# Access Compliance Report

## Public Rights-of-Way

Intersection ID: 32284	Main Street: LANDING_PLACE_LN	Cross Street: STEWARTS_BEND_LN	Location: SW
ADA ID: 756AAF36D2DF	Ramp Type: PerpDiag	Initial Pass/Fail: Fail	Overall Compliance: No
		Severity Score: 10

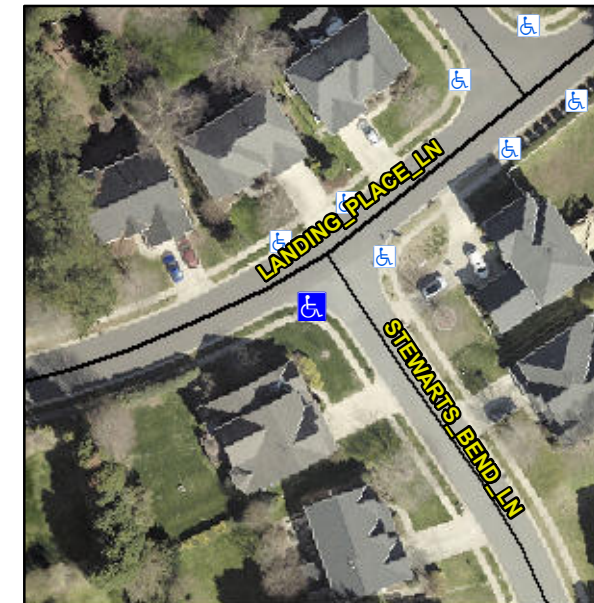
**Not Found, R304.5.1, R304.5.3**

Compliance	Description	Data	Compliance	Description	Data
N/A	Ramp Length (in)	49.0	Yes	Ramp Slope (%)	7.8
No	Ramp Width (in)	41.0	No	Ramp XSlope (%)	2.6
N/A	Flare Type LT	N/A	N/A	Flare Type RT	N/A
N/A	Flare Slope LT (%)	N/A	N/A	Flare Slope RT (%)	N/A
N/A	Flare Traversable LT?	N/A	N/A	Flare Traversable RT?	N/A
N/A	Landing Length (in)	N/A	N/A	DWS Provided?	N/A
N/A	Landing Width (in)	N/A	N/A	DWS Contrast?	N/A
N/A	Landing Slope (%)	N/A	N/A	DWS Length (in)	N/A
N/A	Landing X Slope (%)	N/A	N/A	DWS Full Width?	N/A
N/A	Landing Curb? (Y/N)	N/A	N/A	DWS Offset (in)	N/A
N/A	Shared Landing?	N/A			
N/A	Gutter Ponding?	N/A	N/A	Gutter Slope (%)	N/A
N/A	Gutter Lip Ht (in)	N/A	N/A	Gutter X Slope (%)	N/A
N/A	Painted X Walk1?	No	N/A	Painted X Walk2?	No
	X Walk 1 Direction	To NE		X Walk 2 Direction	To N
N/A	X Walk 1 Width (in)	N/A	N/A	X Walk 2 Width (in)	N/A
	X Walk 1 Slope (%)	3.0		X Walk 2 Slope (%)	4.9
	X Walk 1 X Slope (%)	4.7		X Walk 2 X Slope (%)	1.1

**Remove & Replace Curb Ramp With Two New Directional Ramps or Equivalent.**
